RE: New Hampton CSD - Electrical Pricing Revised - Added Classroom and Gym Occupancy Sensors

New Hampton CSD 5-6/7-8 MS & HS Additions Project:

Change #: ADD SENSORS TO GYM AND CLASSROOMS

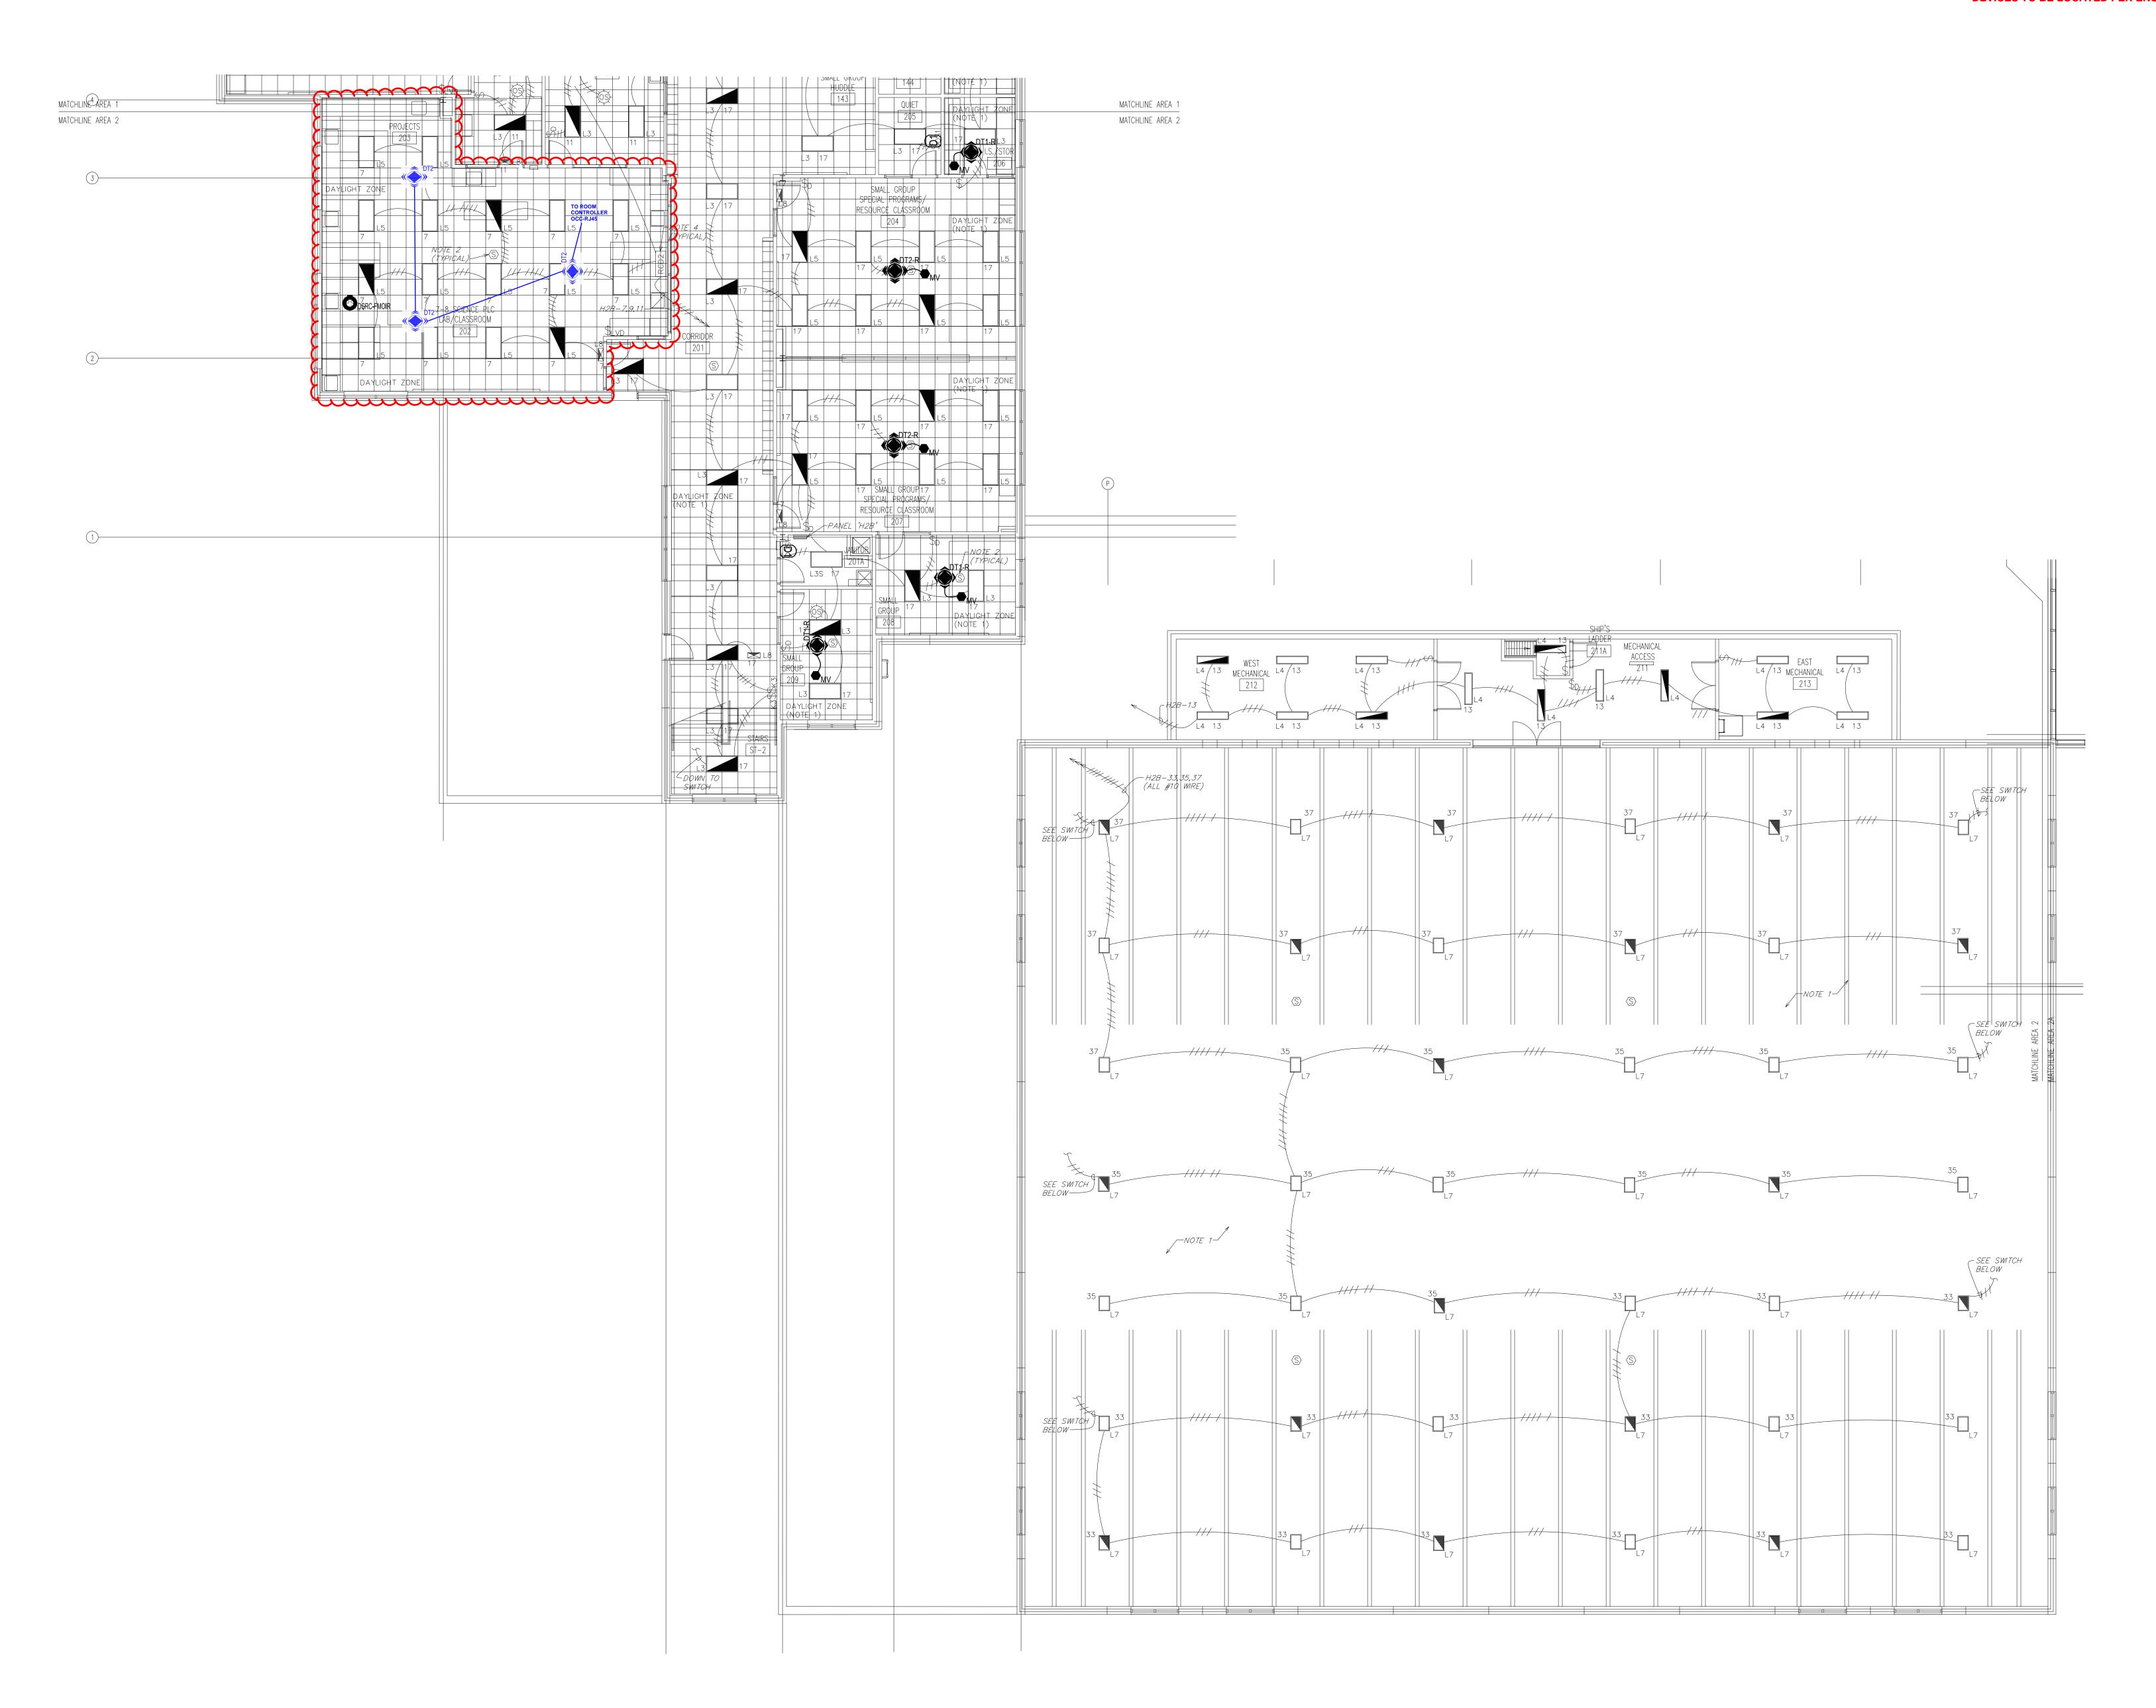
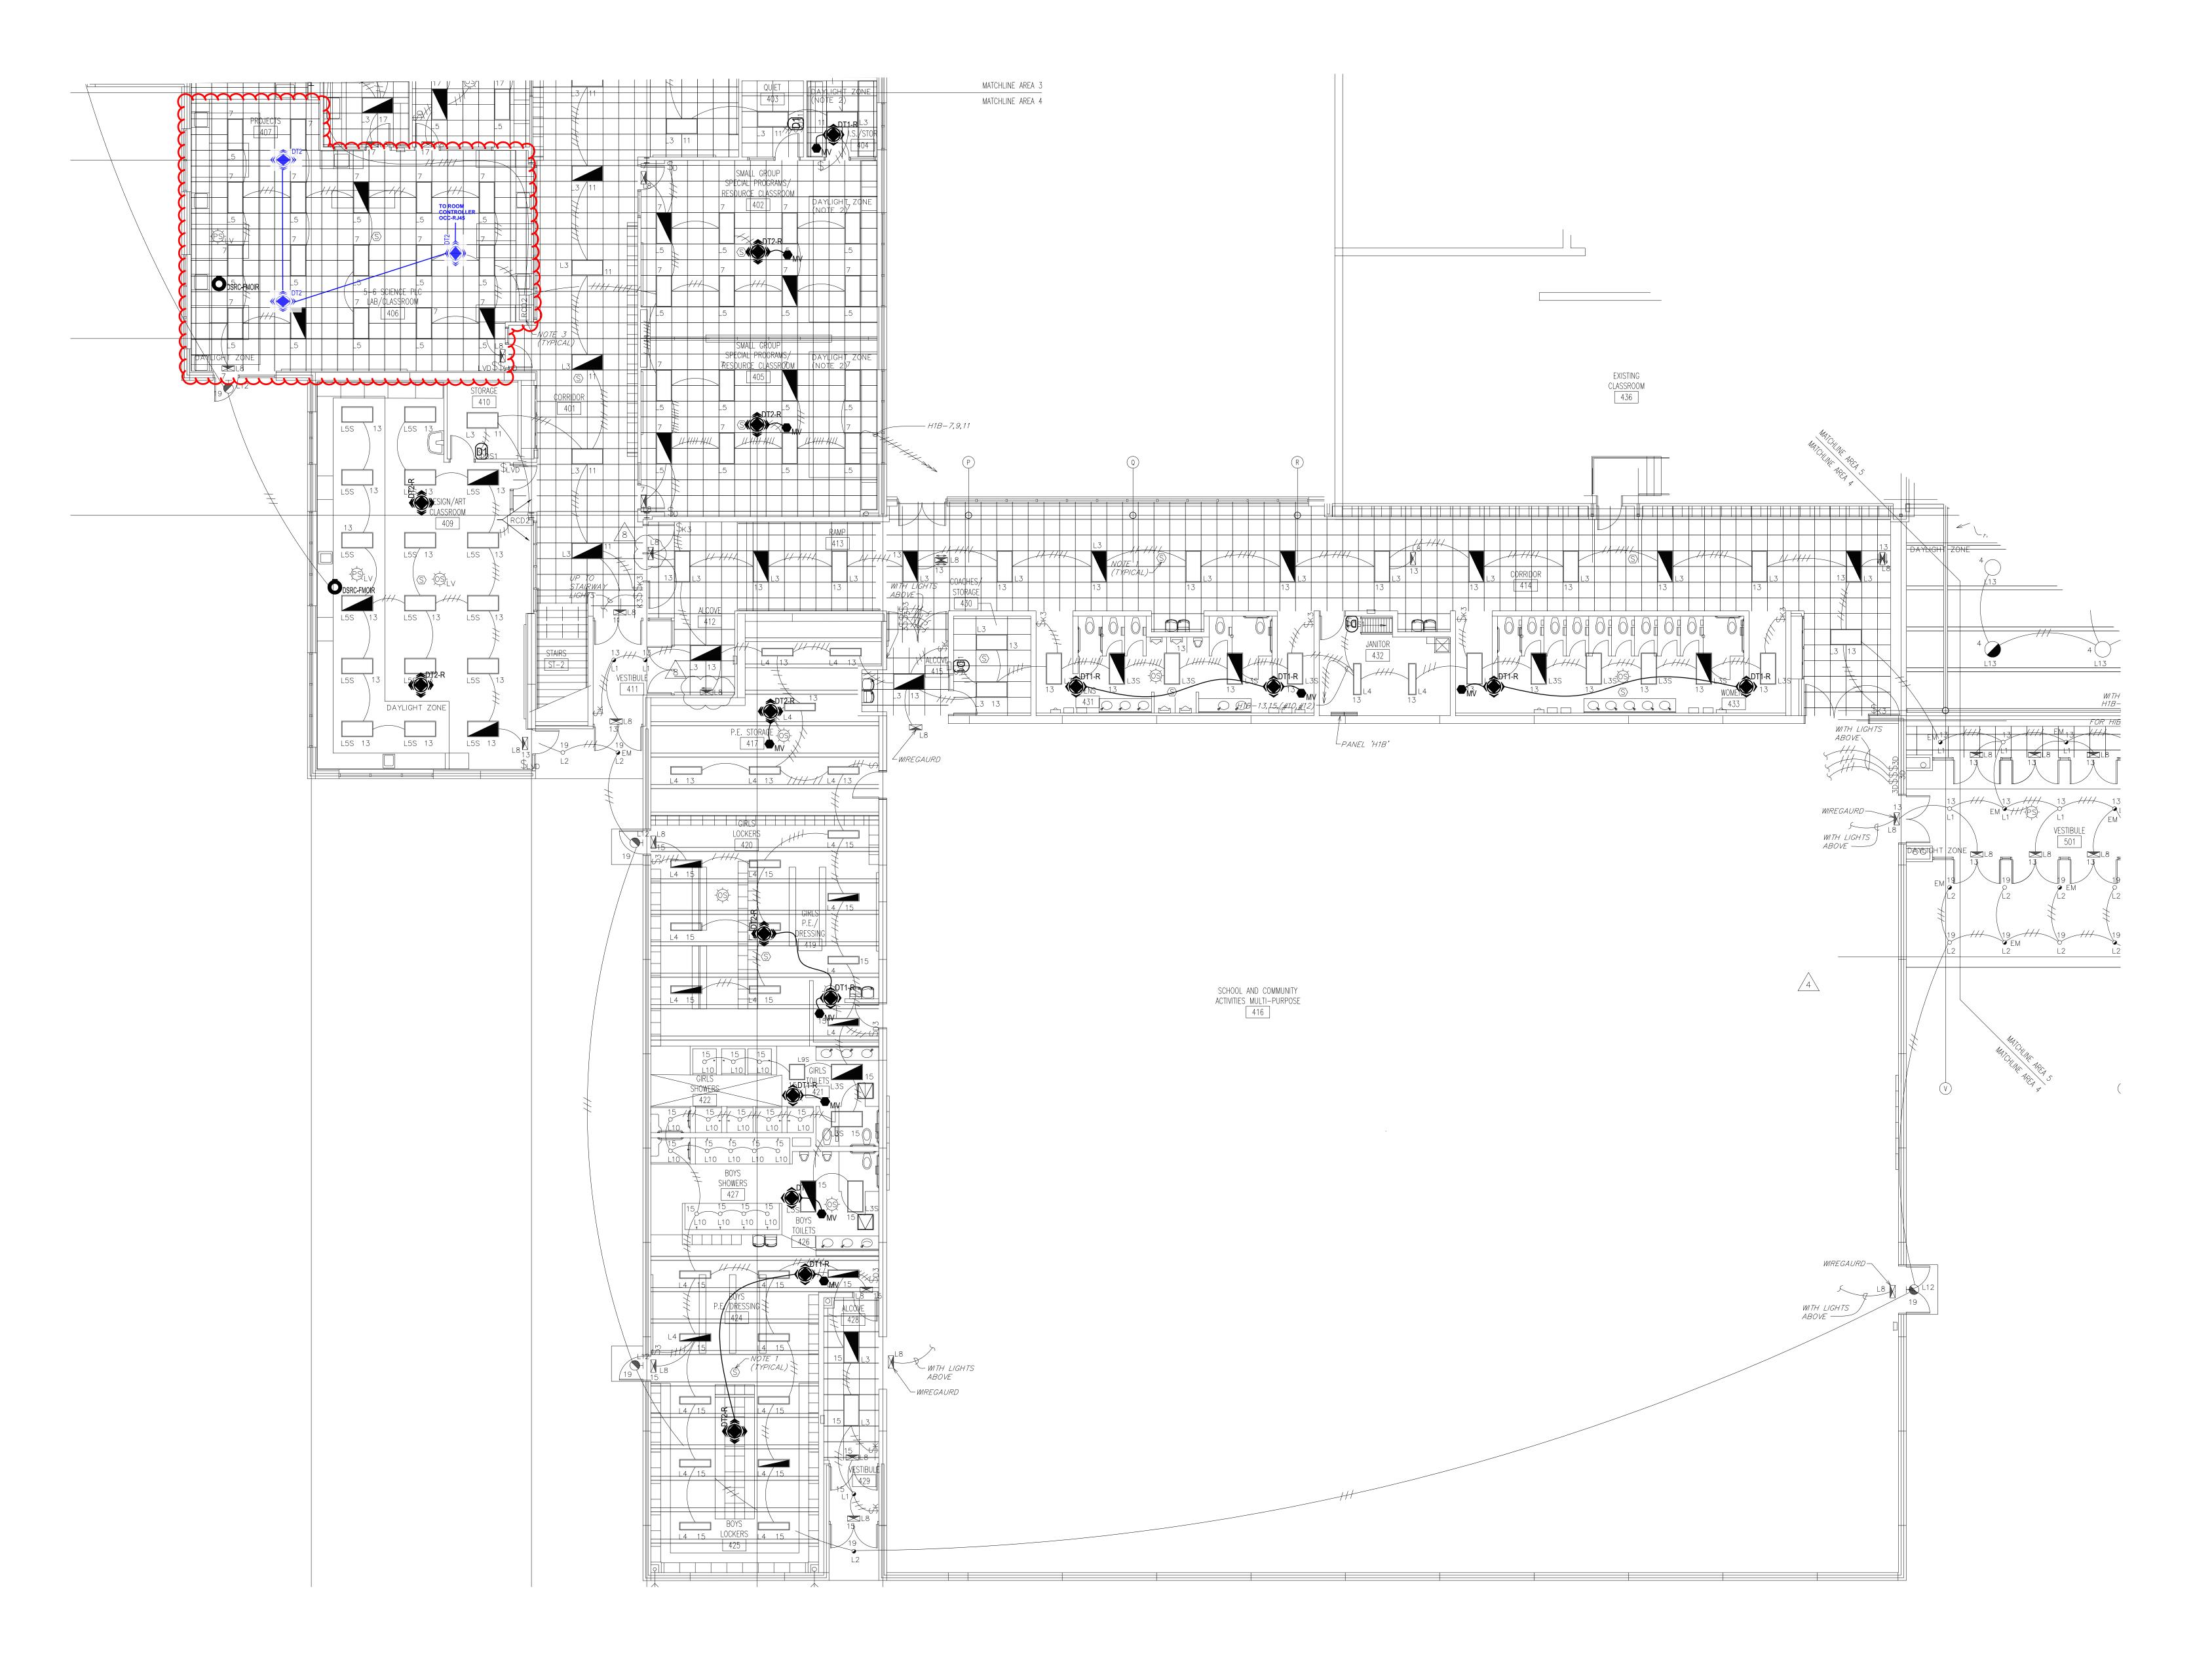
Includes Occupancy Sensors, Power Packs, controls, conduit, wiring, labor, as shown on the attached drawing, for 24 classroom locations and 3 high bay locations in the gym. We are also including 4 dimmer switches for the Gym. These Occupancy Sensors will provide a quick payback in ensuring that the lighting is properly turned off during non-use and may qualify for a Utility Credit.
